# Brookline Preservation Commission

## Local Historic District Report

**Local Historic District:** Pill Hill

**Address:** 15 Circuit Road

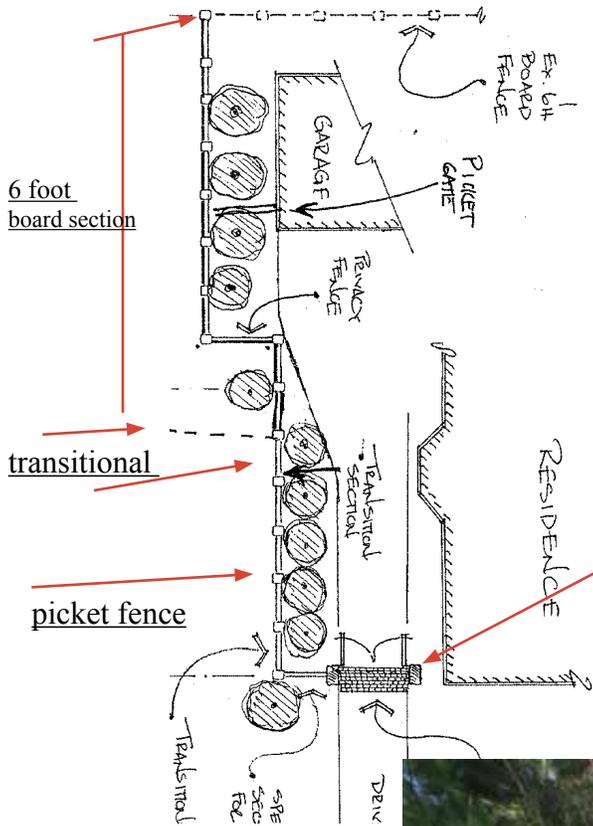
**Preliminary Findings:** The picket fence “Chestnut Hill” is the appropriate height and design. The request for the board fence to start in front of the rear plane of the house is not unreasonable; the fence is far enough away from the house as to not obscure significant features and it does allow for its entire visibility from the street. The trees along the driveway to the garage will be removed.
